Product hierarchy no. *			Part no.	SBU	Type / Description	Customer part no.
SBU	PG	PUG	Type			
02	005	016	0000001202	See list below	Power entry module	1062

Product Change Notification							1062 Power Entry Module	
owner	creation date	release date	released by	change order no	rev	page	D10-034-451	
sariogar	01.03.2019	02.04.2019	limachcl	2017224	A	1 of 3

Old product appearance	New product appearance
<p style="text-align: center;">Front side</p>  <p style="text-align: center;">Back side</p> 	<p style="text-align: center;">Front side</p>  <p style="text-align: center;">Back side</p>

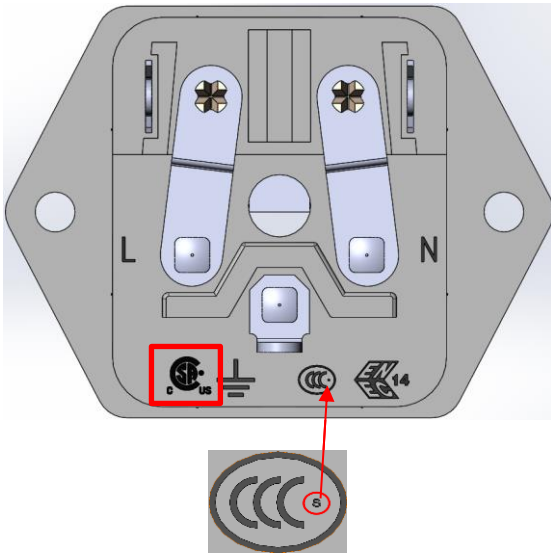
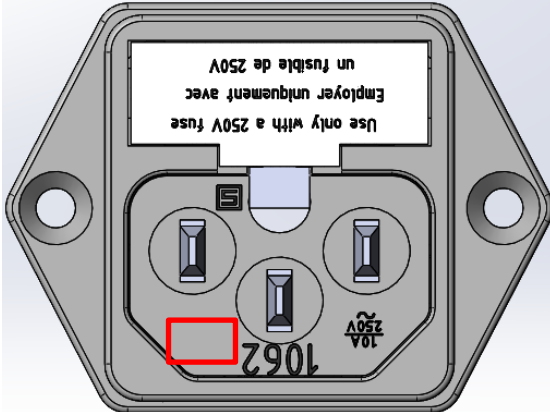
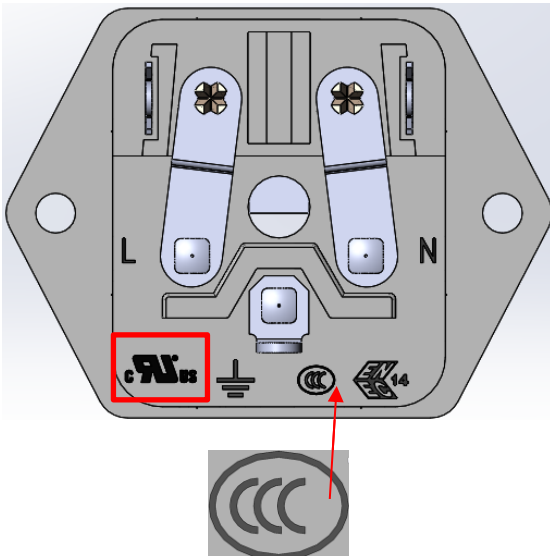
- Change of approval marks on the product
- Change of approval marks on the packaging label

3 Detailed description of change

- Standards update according to the new UL/CSA 60320-1
- Simplification of compulsory CCC mark

Old product appearance	New product appearance
Part numbers with different back side: 4304.6145, 4304.6151, 4304.6180

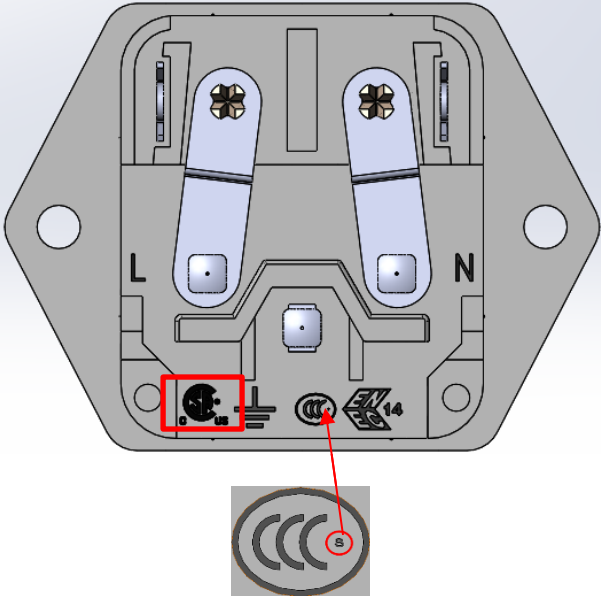
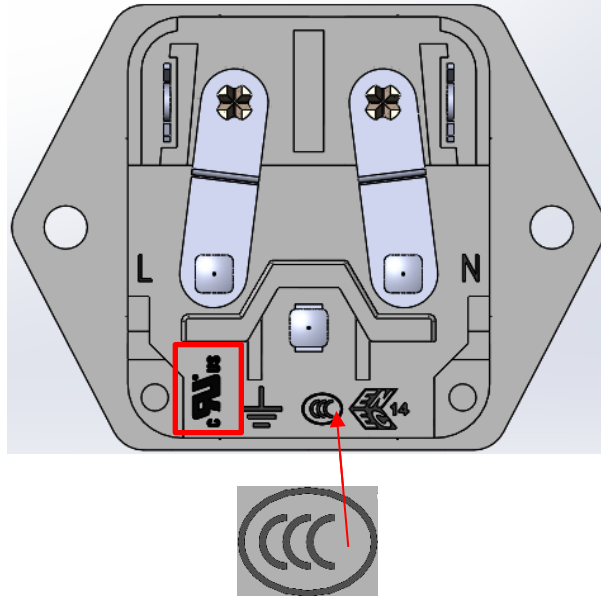
Please note that only screw mounting types are illustrated. However, the same changes apply to both mounting types with screw flange and snap-in as listed in the affected part numbers list in chapter 1.
